From: [REDACTED]
To: [REDACTED]
CC: [REDACTED]
Sent: 3/23/2021 4:49:34 PM
Subject: RE: O8W-PM 35217268, 35224712, 35224713 - Bucks Creek 1101 Phase 1,2&3 - Pre-Engineering Meeting

Subject: O8W-PM 35217268, 35224712, 35224713 - Bucks Creek 1101 Phase 1,2&3 - Pre-Engineering Meeting

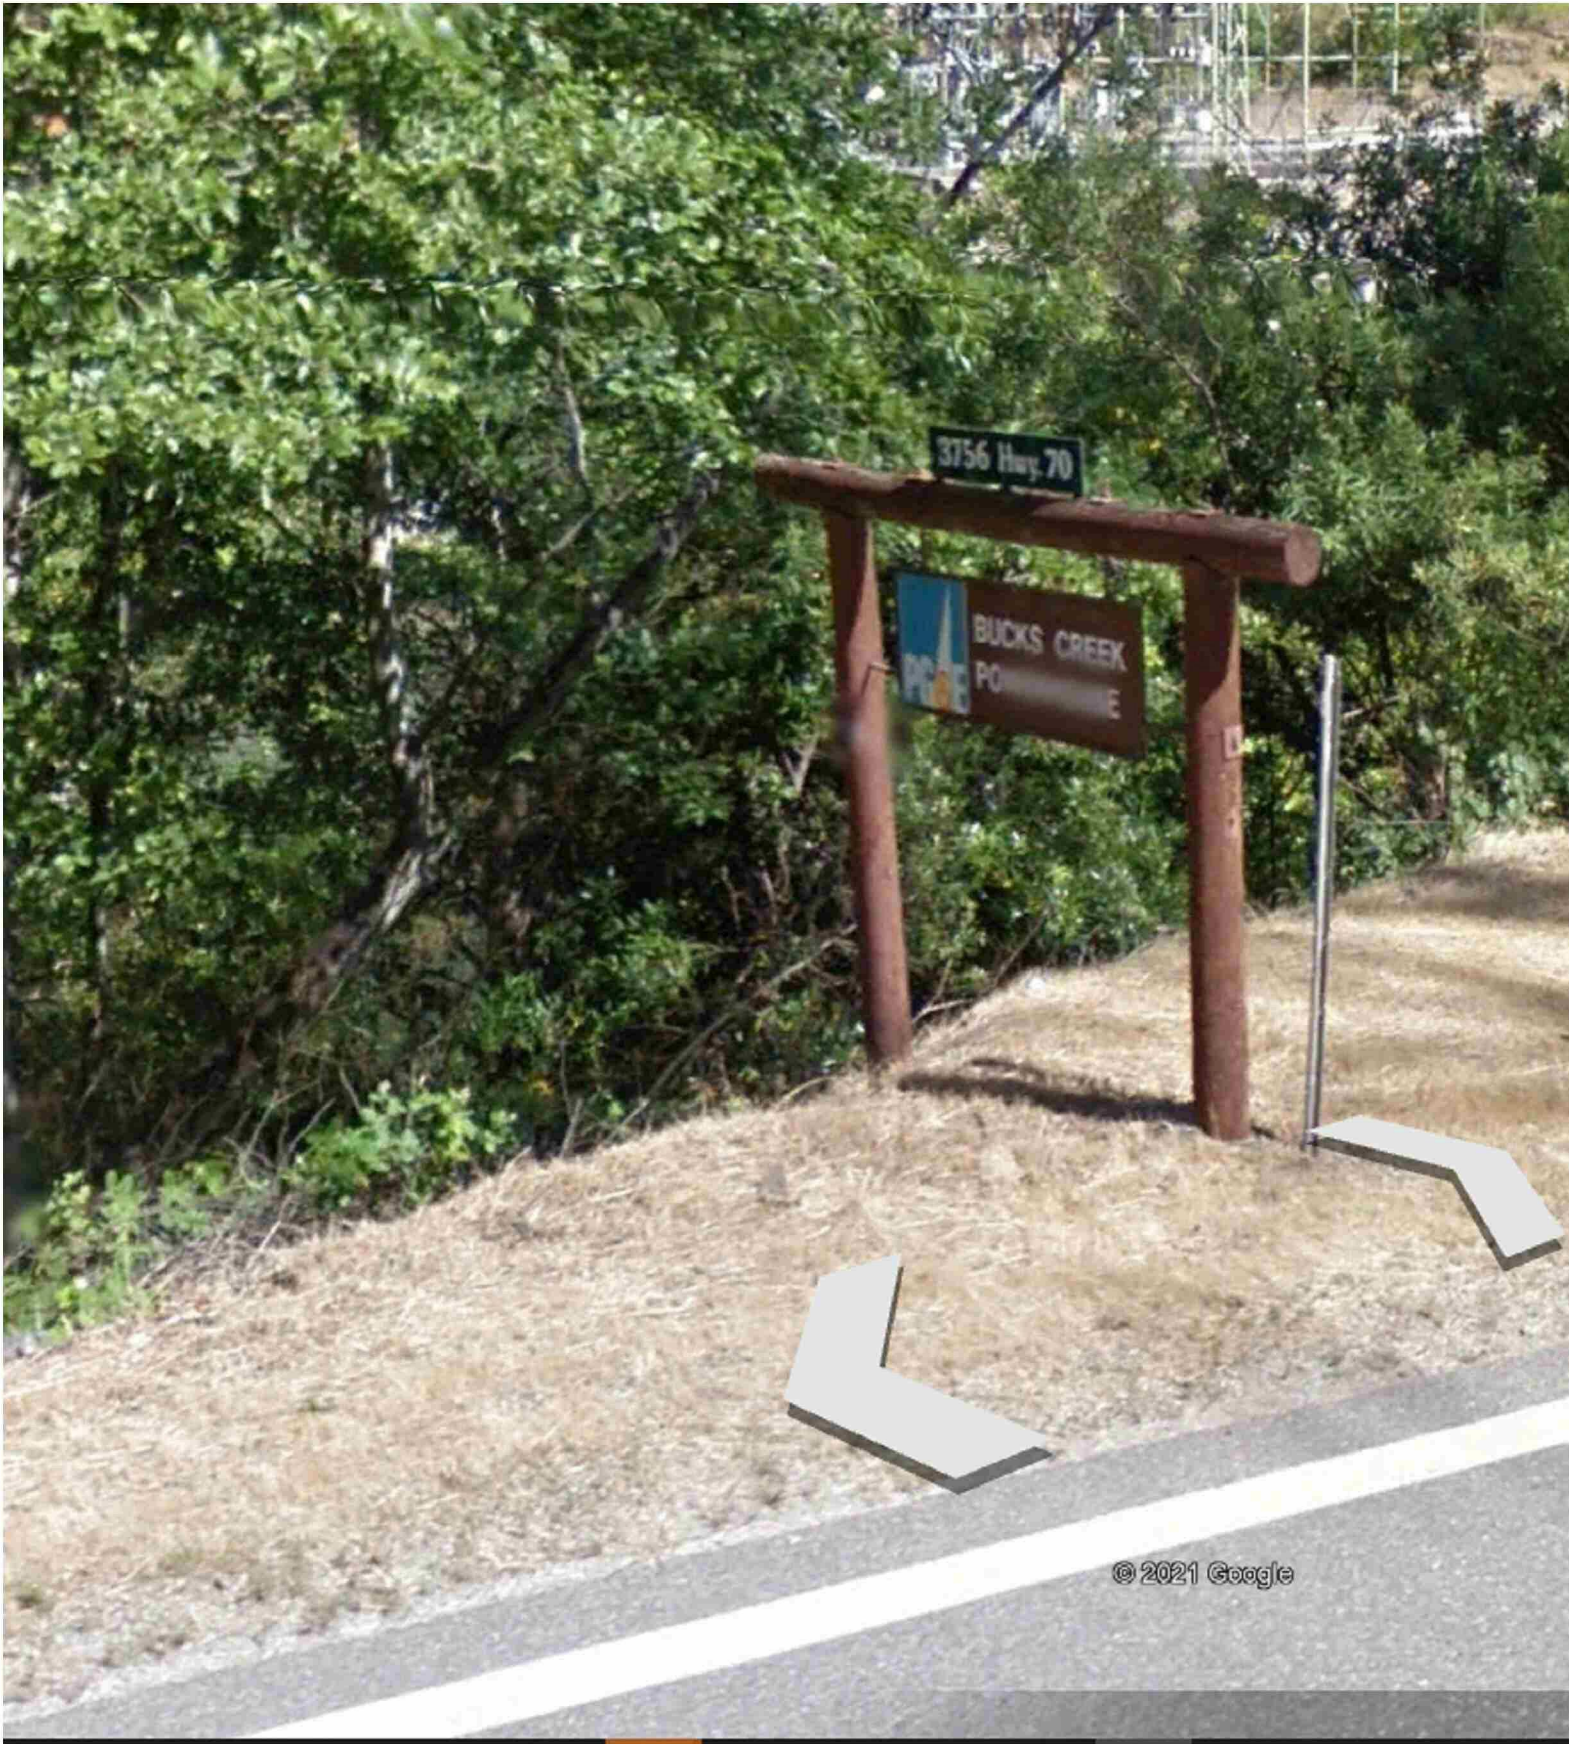
Attached are the 'base-map' limits in a kmz. file. As you will see, we need our base-map to go about ~100' into the tunnel at the south end (see pedestal in picture below....please begin about ~50 beyond this point which is about ~100' beyond the Cresta Dam).
